STOKLEY CORNER SUBDIVISION

Engineering Comments: FINAL PLAT COMMENTS (should be addressed prior to submitting the FINAL PLAT for review and/or signature by the City Engineer):

The plat illustrates the proposed 2-lot, 1.3±-acre subdivision located at the Southwest corner of Government Street and Stocking Street, extending to the North side of Church Street, 200'± West of Stocking Street, in Council District 2. The applicant states the site is served by public water and sanitary sewer systems.

The purpose of this application is to create two (2) legal lots of record from two (2) metes-and-bounds parcels.

DETAIL SITE PLAN

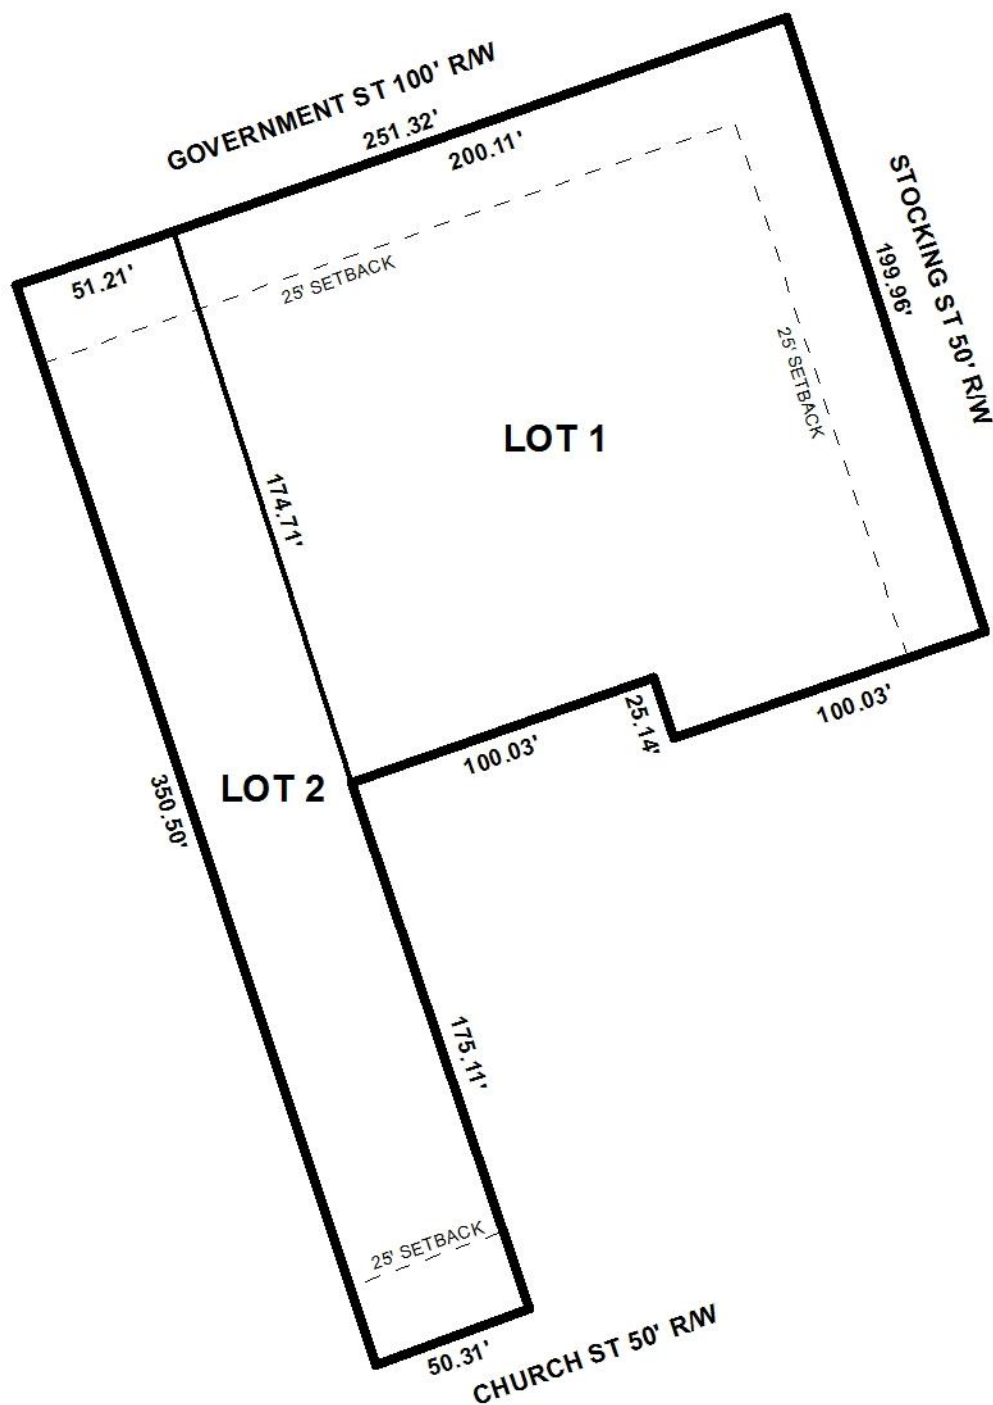
- B. Dedicate the corner radius (25' minimum or as approved by the City Engineer and Traffic Engineer) at the northeast corner of LOT 1 to the City of Mobile, and list the amount of dedicated acreage.

Proposed Lot 1 has frontage along Government Street and Stocking Street. Proposed Lot 2 has frontage along Government Street and Church Street. Government Street is a major street which requires a 100' right-of-way; and Stocking and Church Streets are both minor streets with curb and gutter, each requiring a 50' right-of-way. Adequate right-of-way is illustrated along all streets, thus no additional dedications should be required.

Revision of the plat to illustrate dedication of a 25' corner radius at the intersection of Government Street and Stocking Street should be required, if approved, per Section V.D.6. of the Subdivision regulations.

It should be noted that proposed Lot 2 is substandard in width, which contributes to a lot depth greater than the 3.5 ratio allowed by the Subdivision Regulations. The lot appears, however, to have existed in its current configuration prior to current regulations, thus waivers of Sections V.D.2. and V.D.3. may be appropriate.

Regarding access management, Lot 1 should be limited to one (1) curb cut to Government Street and no more than two (2) curb cuts to Stocking Street; and, Lot 2 should be limited to one (1) curb cut to Church Street. Also, any changes in the sizes, locations, or designs of the curb cuts are to be approved by ALDOT, where applicable along Government Street, and Traffic Engineering, and should conform to AASHTO standards.

Finally, the 25' minimum building setback line is illustrated along all street frontages, in compliance with Section V.D.9. of the Subdivision Regulations, and should be retained on the Final Plat, if approved, adjusted for dedication.

- 1) revision of the plat to illustrate dedication of a 25' corner radius at the intersection of Government Street and Stocking Street, per Section V.D.6. of the Subdivision regulations;

- 2) retention of the lot sizes in square feet and acres on the Final Plat, or placement of a table on the Final Plat providing the same information, adjusted for dedication;

- 3) placement of a note on the Final Plat stating Lot 1 is limited to its existing curb cuts(s), and Lot 2 is limited to one (1) curb cut each to Government Street and Church Street, with any changes in their sizes, locations, or designs to be approved by Traffic Engineering and conform to AASHTO standards;

- 4) retention of the 25' minimum building setback line along all street frontages, adjusted for dedication;
- 5) compliance with Engineering comments: (FINAL PLAT COMMENTS *(should be addressed prior to submitting the FINAL PLAT for review and/or signature by the City Engineer):* A) Provide all of the required information on the SUBDIVISION PLAT (i.e. signature blocks, signatures, certification statements, written legal description, required notes, legend, scale, bearings and distances) that is required by the current Alabama State Board of Licensure for Professional Engineers and Land Surveyors. B) Dedicate the corner radius (25' minimum or as approved by the City Engineer and Traffic Engineer) at the northeast corner of LOT 1 to the City of Mobile, and list the amount of dedicated acreage. C) Provide the Surveyor's, Owner's (notarized), Planning Commission, and Traffic Engineering signatures. D) Add a note to the SUBDIVISION PLAT stating that a Land Disturbance permit will be required for any land disturbing activity in accordance with Mobile City Code, Chapter 17, Storm Water Management and Flood Control); the City of Mobile, Alabama Flood Plain Management Plan (1984); and, the Rules For Erosion and Sedimentation Control and Storm Water Runoff Control. E) Add a note to the Plat stating that the approval of all applicable federal, state, and local agencies (including all storm water runoff, wetland and floodplain requirements) will be required prior to the issuance of a Land Disturbance permit. F) Add a note that sidewalk is required to be constructed, and/or repaired, along the frontage of each lot, or parcel, at time of new development or construction, unless a sidewalk waiver is approved. G) Add a note to the plat stating that all proposed detention facilities, common areas, and wetlands shall be the responsibility of the Property Owner(s), and not the responsibility of the City of Mobile. H) Add a note to the plat stating that all easements shall remain in effect until vacated through the proper Vacation process. I) Provide a copy of the FINAL SUBDIVISION PLAT to the Engineering Dept. for review. No signatures are required on this drawing. J) After addressing all of the FINAL SUBDIVISION PLAT review comments by the Engineering Dept. provide the red-line markup, the ORIGINAL (with all other signatures) and one (1) copy of the revised
